COMMITTEE OF ADJUSTMENT COMMENTS FROM STAFF, PUBLIC & AGENCIES

APPLICATION NUMBER: B-19/15
LOCATION: 44 Fair Road
DATE AND TIME OF HEARING: October 8, 2015 at 4:00 p.m.
OWNER: HVM Holdings Inc.
AGENT: Hank Vercooteran, Arhan Project Management & Design
OFFICIAL PLAN DESIGNATION: Industrial
ZONING: Industrial (B.4) Zone

SKETCH FOR PLANNING PURPOSES
LOT 14, REGISTERED PLAN 797
CITY OF GUELPH COUNTY OF WELLINGTON

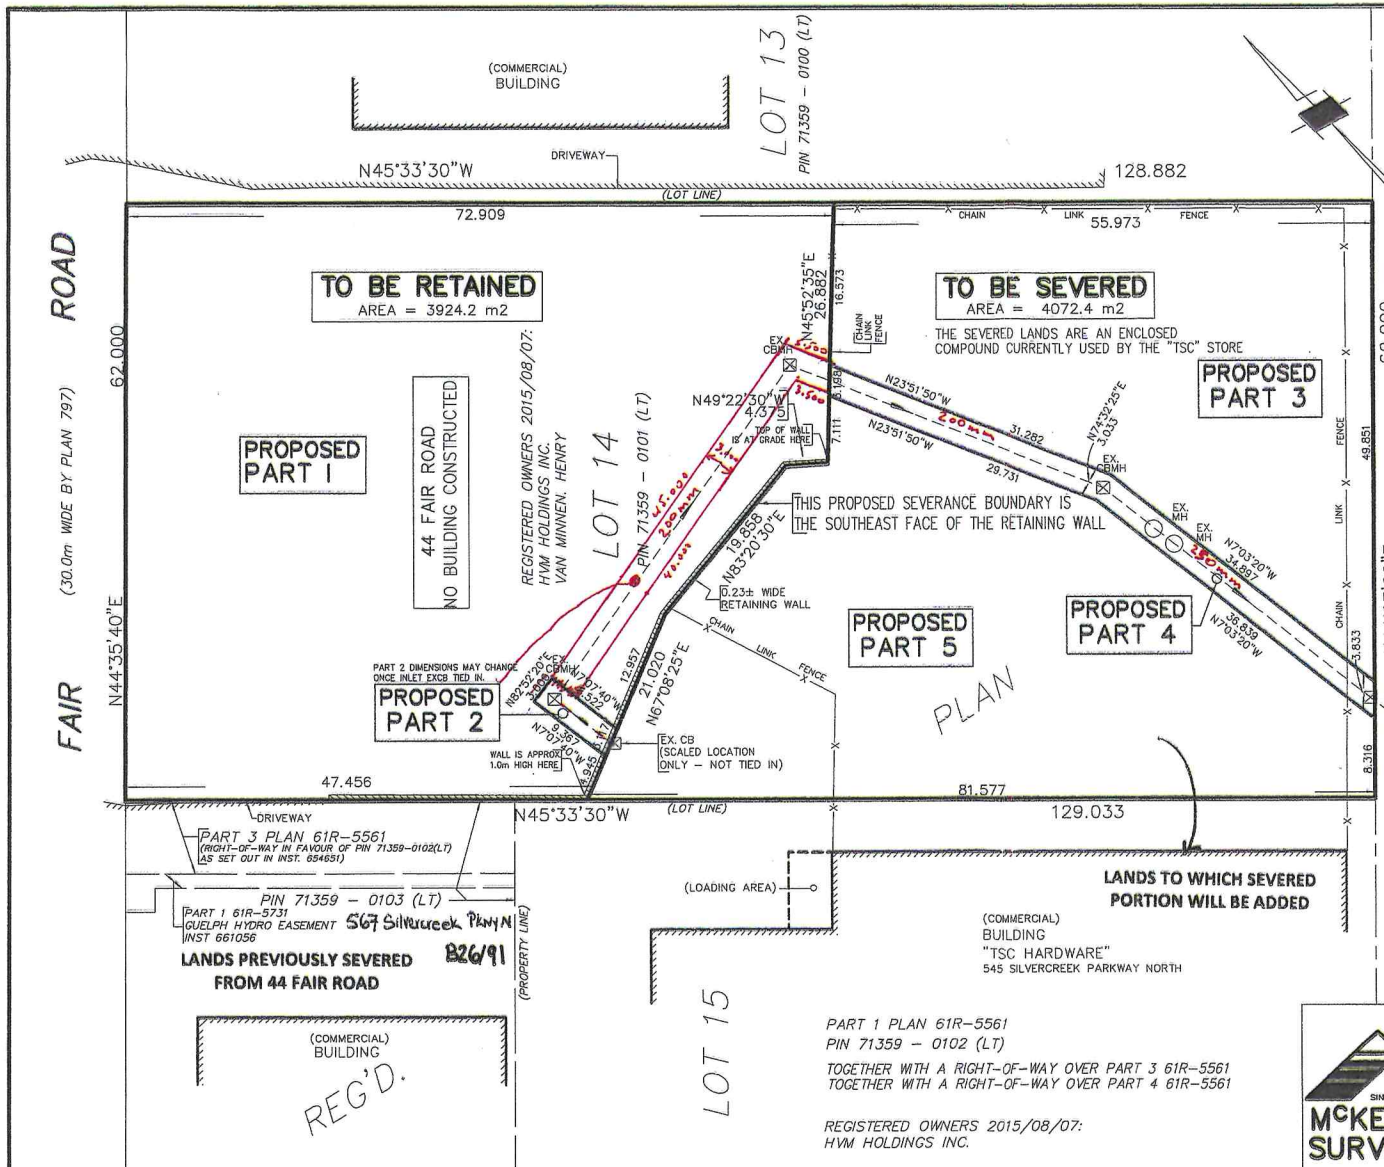
The applicant's plan shows the existing 200 millimetre (mm) and 250 millimetre (mm) storm

sewer system on the proposed retained lands (Parts 1 and 2) and proposed severed lands (Parts 3, 4 and 5) that outlets into the existing 1400 millimetre (mm) storm sewer located on the adjacent lands. Once the severed portion is added to 545 Silvercreek Parkway North, the owner of the proposed retained lands (44 Fair Road, servient tenement, Lot 14, Registered Plan 797, Parts 1 and 2) shall grant an easement approximately 3.0-metres (9.84 feet) wide by approximately 54.44-metres (178.60 feet) long, registered on title, in favour of the proposed severed lands (545 Silvercreek Parkway North, dominant tenement, Parts 3, 4 and 5) for the use of the existing 200 millimetre (mm) storm sewer. The owner of the proposed severed lands (545 Silvercreek Parkway North, servient tenement, Lot 14, Registered Plan 797, Parts 3, 4 and 5) shall grant an easement approximately 3.033-metres (9.84 feet) wide by approximately 66.37-metres (217.75 feet) long registered on title, in favour of the proposed retained lands (44 Fair Road, dominant tenement, Parts 1 and 2) for the use of the existing 200 millimetre (mm) and 250 millimetre (mm) storm sewer. We have illustrated in red on the applicant's site plan the required easements to assist the Committee.

SEE ATTACHED REDLINE DRAWING.

3. That prior to endorstation of the deeds, the servient tenement (proposed retained lands, 44 Fair Road, Lot 14, Registered Plan 797, Parts 1 and 2) grants an easement approximately 3.0-metres (9.84 feet) wide by approximately 54.44-metres (178.60 feet) long, registered on title, in favour of the dominant tenement, (proposed severed lands, 545 Silvercreek Parkway North, Lot 14, Registered Plan 797, Parts 3, 4 and 5) as shown in red on the applicant's site plan for the use of the existing 200 millimetre (mm) and 250 millimetre (mm) storm sewer.

4. That prior to endorstation of the deeds, the servient tenement (proposed severed lands, 545 Silvercreek Parkway North, Lot 14, Registered Plan 797, Parts 3, 4 and 5) grants an easement approximately 3.033-metres (9.84 feet) wide by approximately 66.37-metres (217.75 feet) long, registered on title, in favour of the dominant tenement, (proposed retained lands, 44 Fair Road, Lot 14, Registered Plan 797, Parts 1 and 2) as shown in red on the applicant's site plan for the use of the existing 200 millimetre (mm) storm sewer.
